City Council Staff Report

Consideration of a Resolution approving the Project Plan and Preliminary Plat application for the Fox Hollow Town Homes consisting of eight townhomes located in the R-2-B zone.

FOX HOLLOW TOWNHOMES

Development Review Committee Minutes

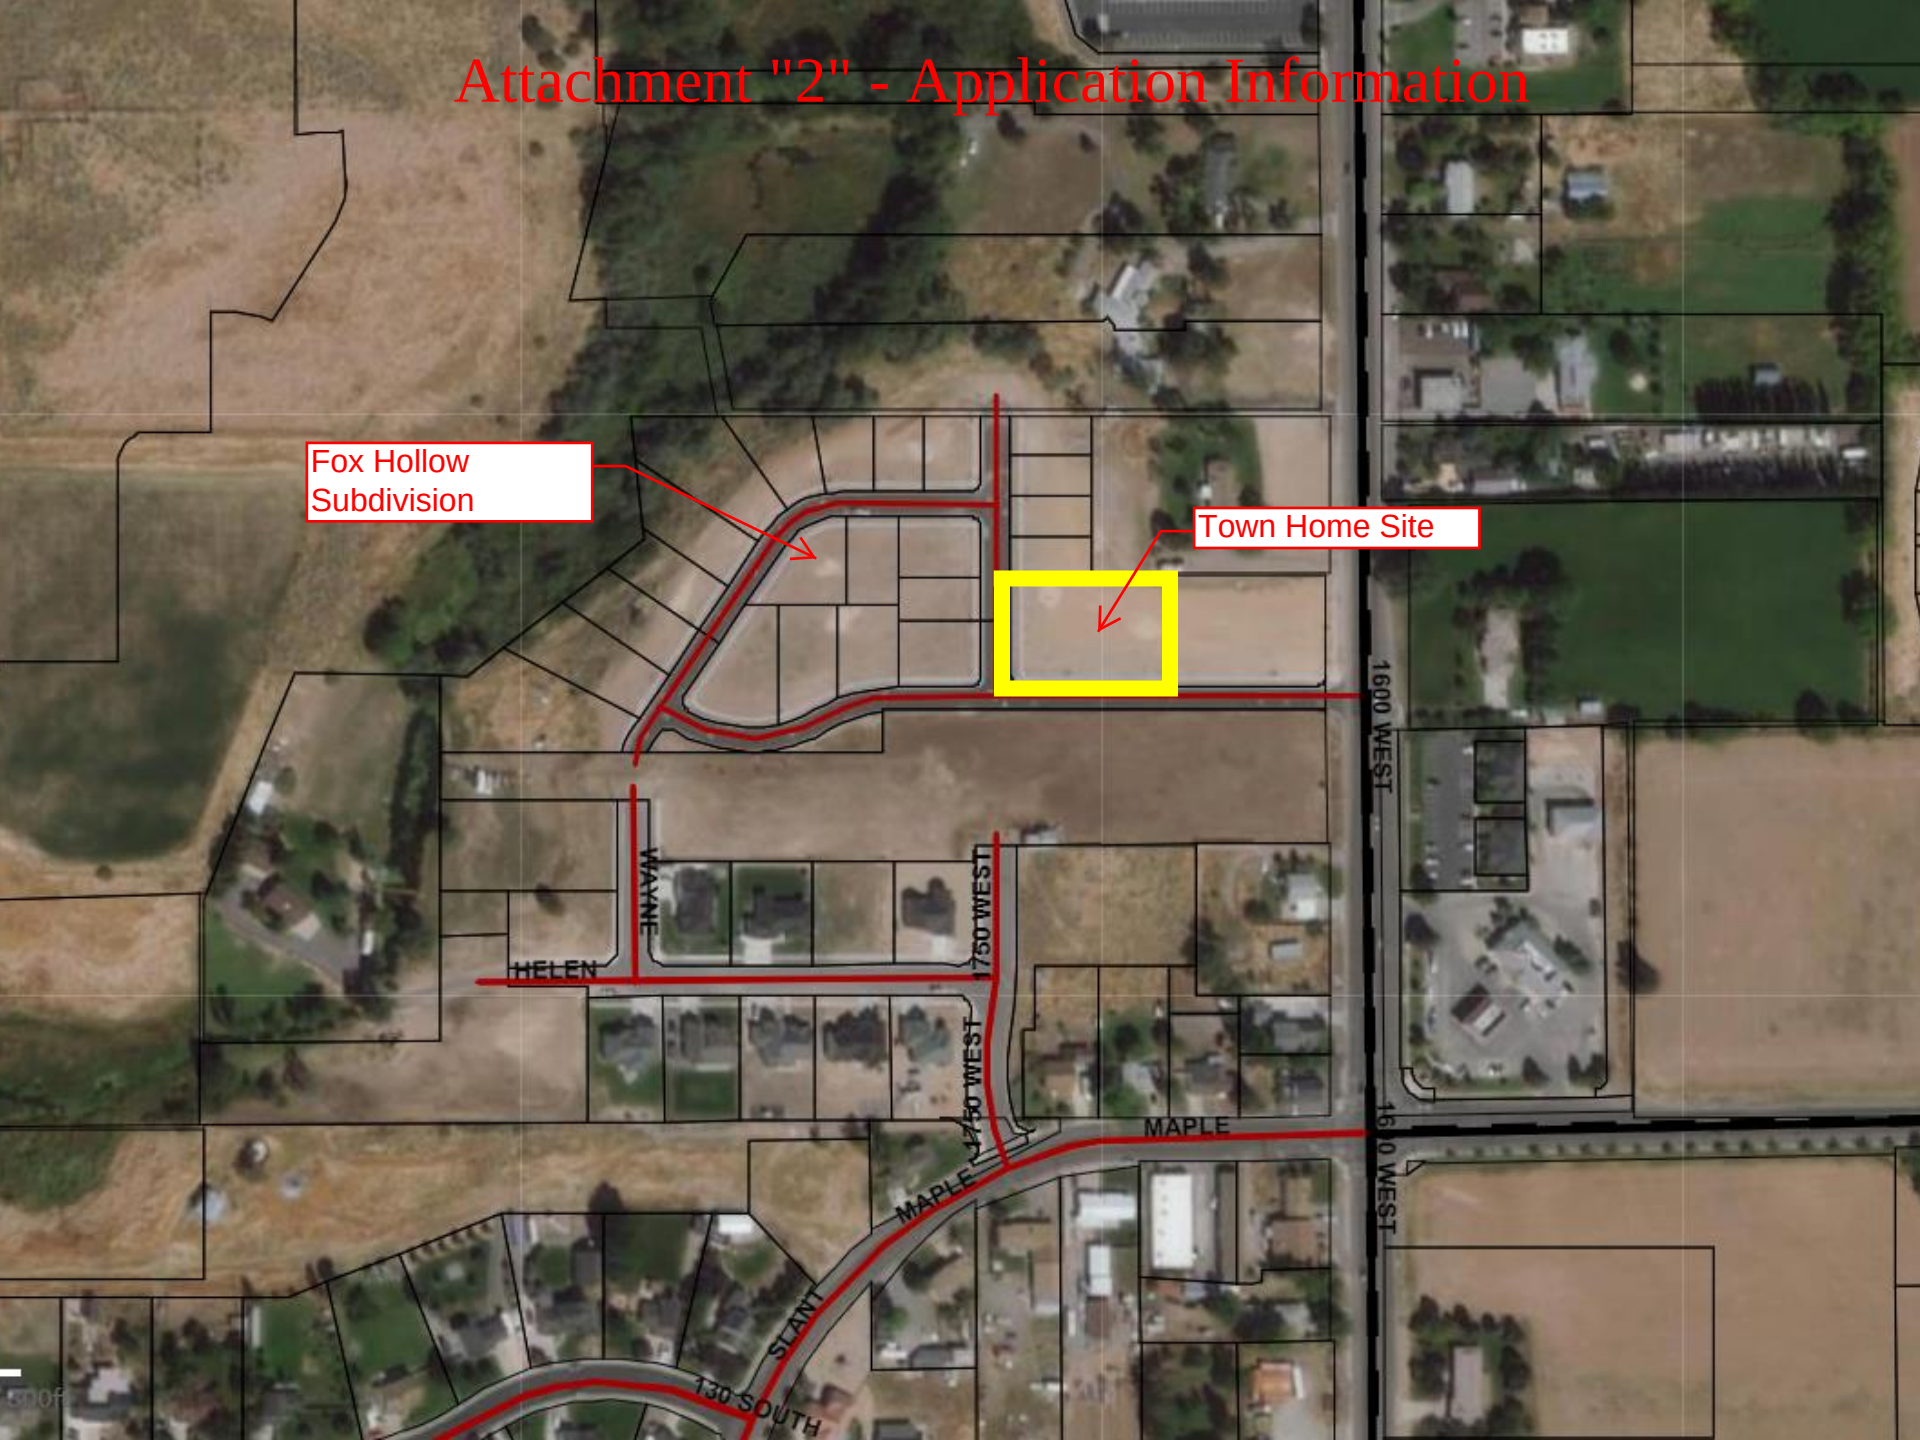
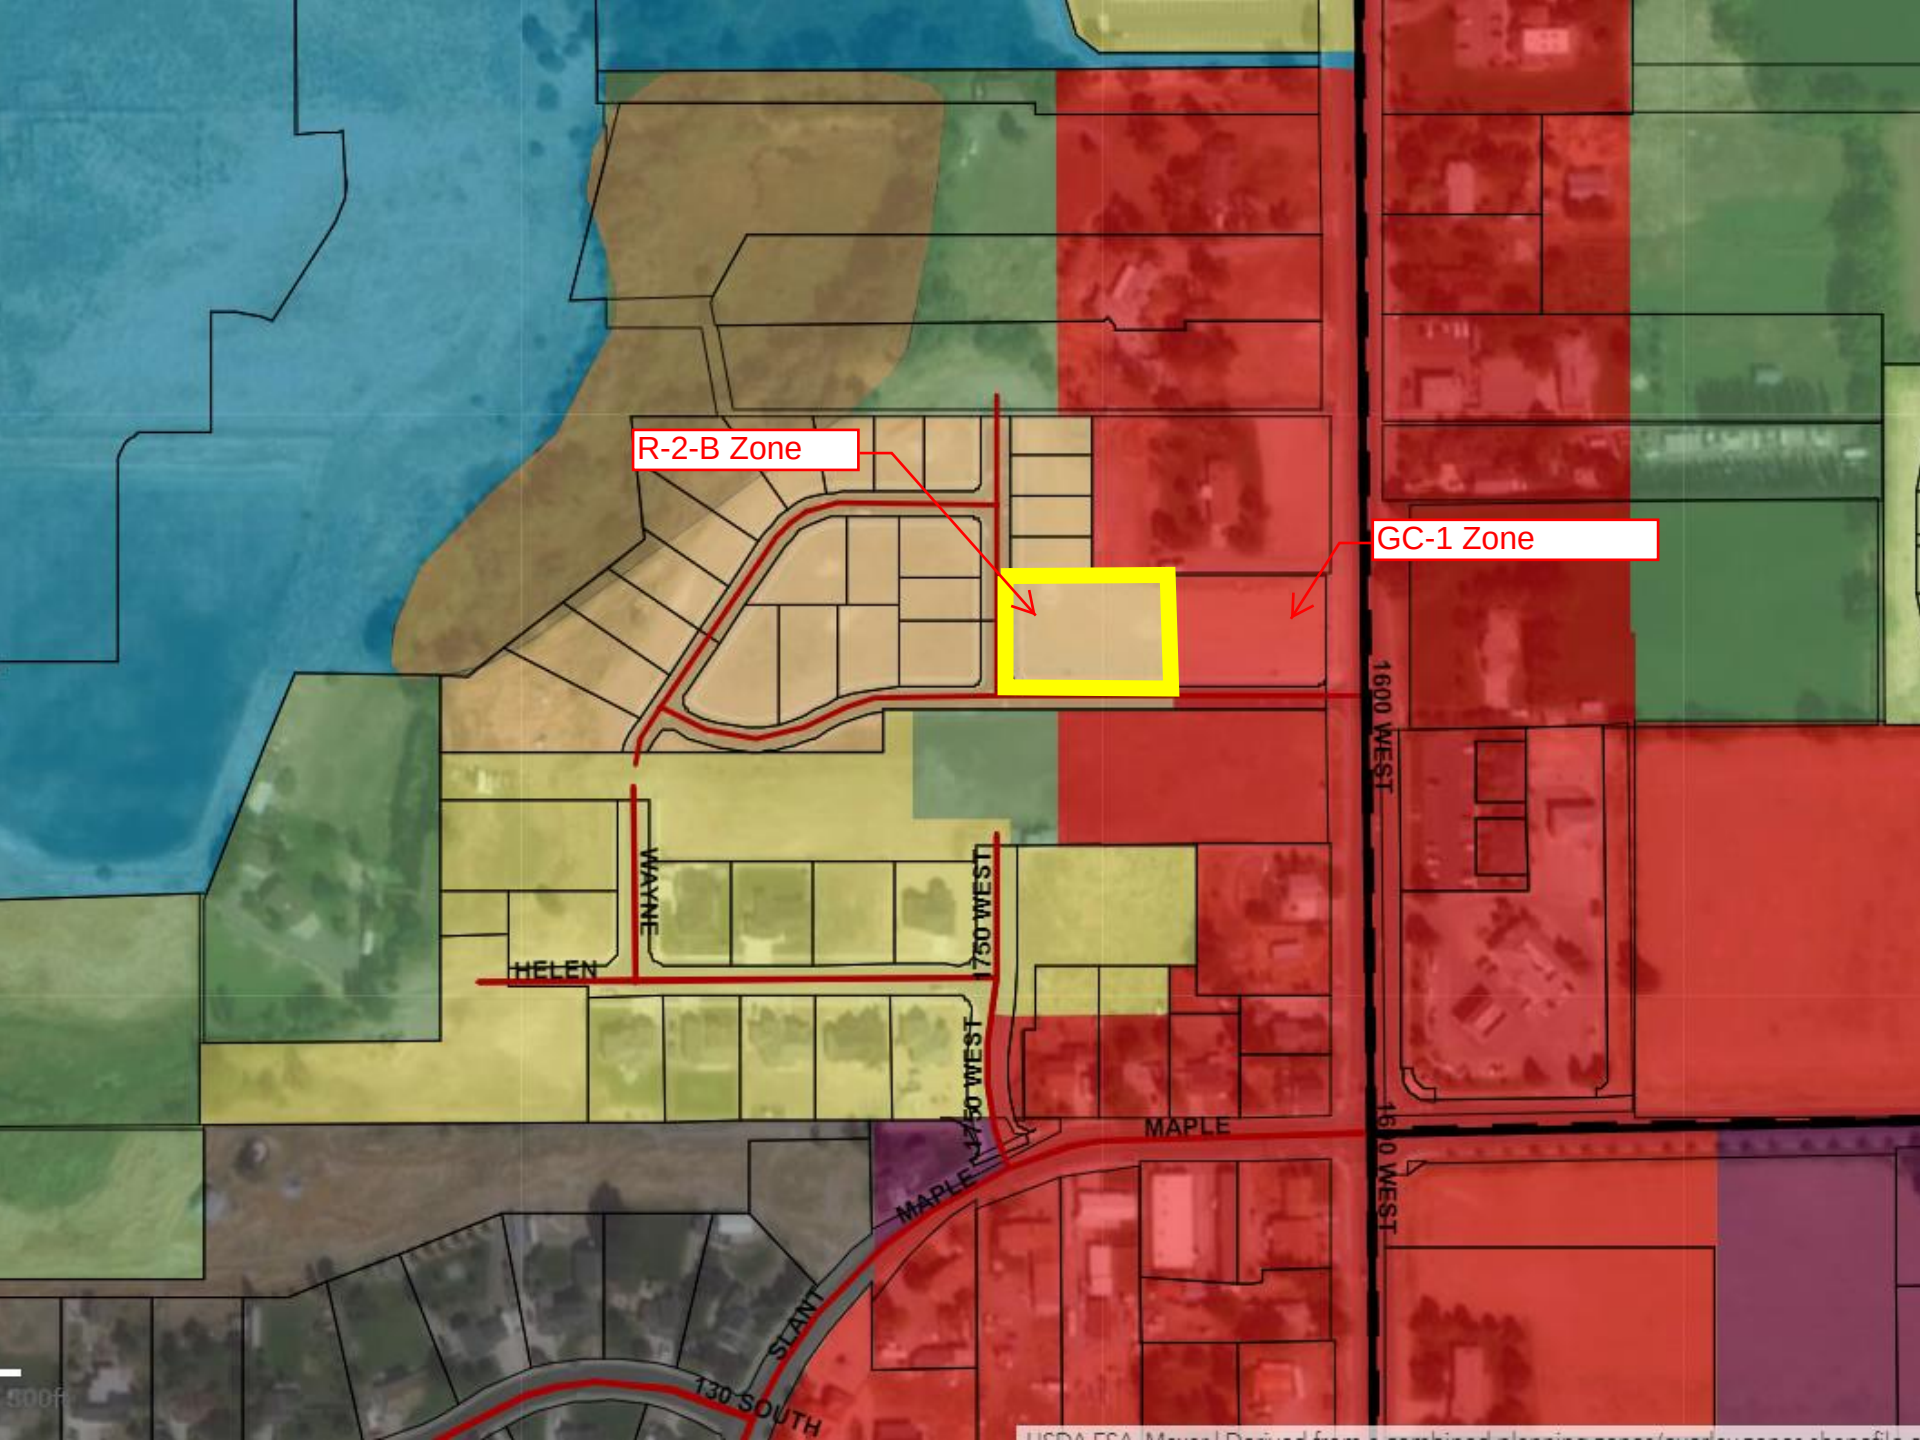
components as required by the code. However, staff recommends that some windows and some architectural elements (pop-out or bay window) be added to the right side elevations of each building to avoid large unrelieved walls that would be visible from the street. The applicant has agreed to make these changes.

Staff recommends adding windows and relief

2. The plans shall be revised to include some windows and architectural elements on the right side elevations of both buildings to avoid large, unrelieved blank walls that are visible from the street.
